Classification of recurrence

Kaplan-Meier (KM) method versus Cumulative Incidence Function (CIF)

Differences in Systematic Literature Review Methodology

Please find FDA's PRISMA flow chart (**Figure 5**) and IceCure Medical's initial PRISMA flow chart (**Figure 6**) below.

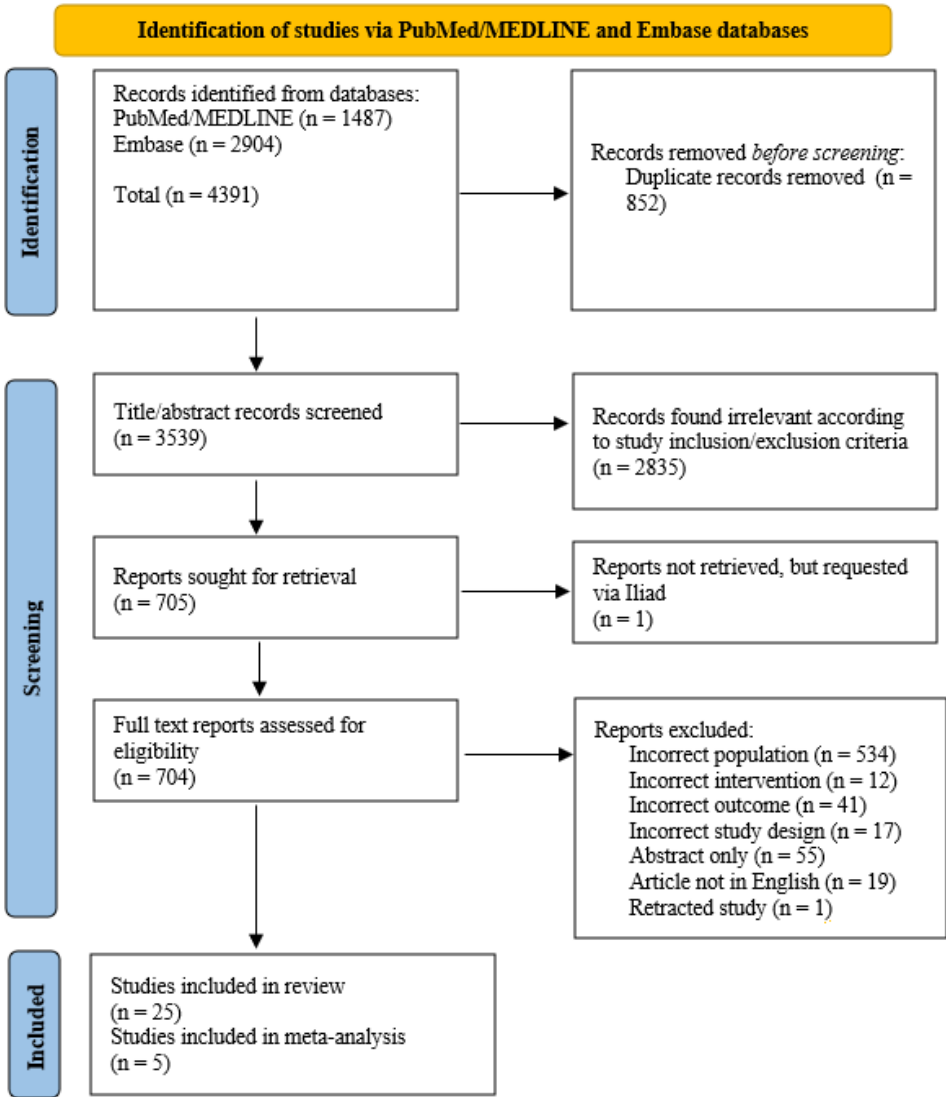
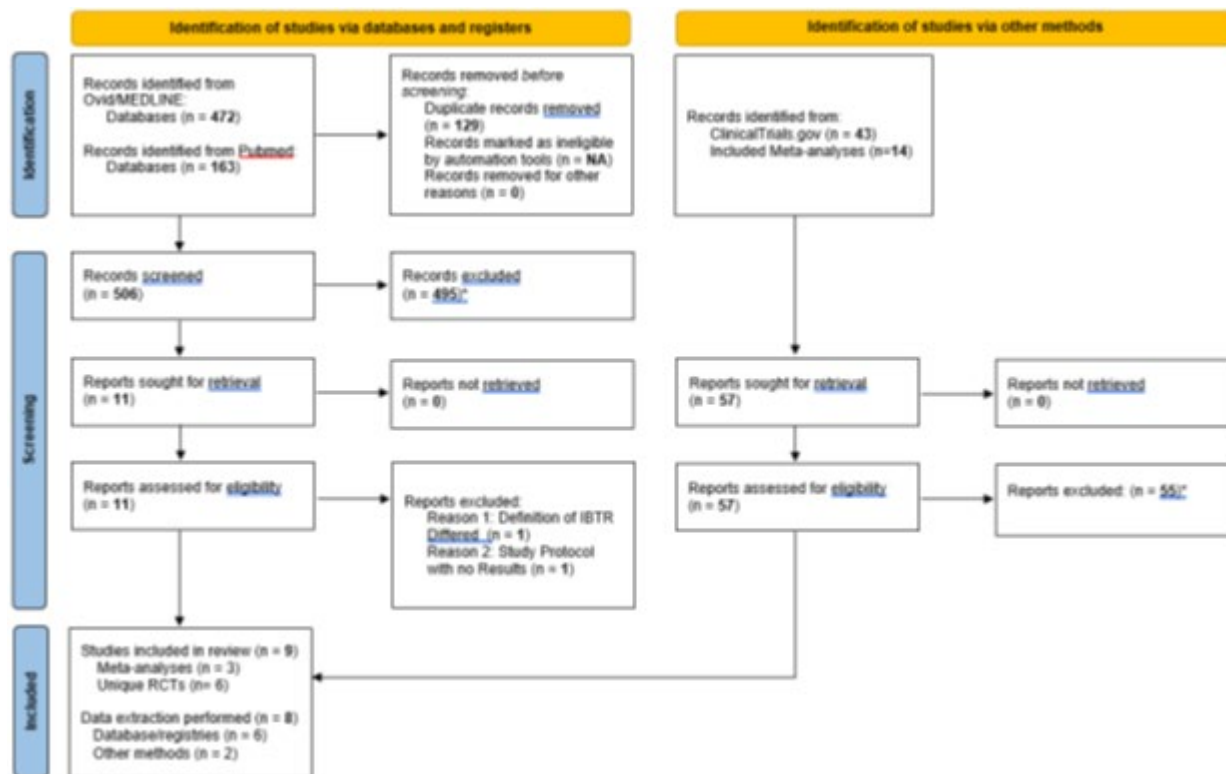
IceCure Medical's SLR and the FDA's SLR utilized different search strategies and terms, which impacted the breadth and specificity of the literature captured. This variance in search methodology is crucial as it directly influences the comprehensiveness and relevance of the systematic review results. FDA searched PubMed/MEDLINE and Embase using targeted search strings. IceCure Medical's search included PubMed, Ovid/Medline, Embase, and ClinicalTrials.gov. Indexing in databases like PubMed and Embase relies on controlled vocabulary terms (like MeSH in PubMed) to categorize studies. These terms help in retrieving literature that is accurately tagged by subject area, methodology, and focus. However, not all studies are indexed uniformly or comprehensively. Discrepancies in how a study is indexed (e.g., missing relevant terms or inconsistent use of synonyms) can lead to its omission from search results if the search terms used are too narrow or not aligned with the indexing terms.

IceCure Medical's search terms, while comprehensive, were potentially limited by not incorporating a wider range of synonymous terms and controlled vocabulary that could capture more specific studies relevant to their criteria. For example, using broad terms like "Early Stage" and "Breast Cancer" might miss studies specifically indexed under sub-categories like "Stage I" or "Low-Risk Breast Cancer." Moreover, not including specific outcome measures like "ipsilateral breast tumor recurrence" or detailed pathological criteria (e.g., "Nottingham Grade" or "Ki-67") in the search could lead to excluding studies that focus precisely on those aspects but are indexed under these specific terms. FDA's search strategy incorporated a diverse range of terms and controlled vocabulary to minimize the risk of missing studies due to indexing limitations. This approach is particularly important when developing meta-estimates for performance goals, as missing even a small subset of relevant studies can skew the results.

Please note the number of “Identified” studies was later updated with 113 additional studies (100 additional studies identified via search of databases and 13 additional studies identified via ClinicalTrials.gov and 3 of these new studies were included in the SLR after screening for a total of 12 studies.)
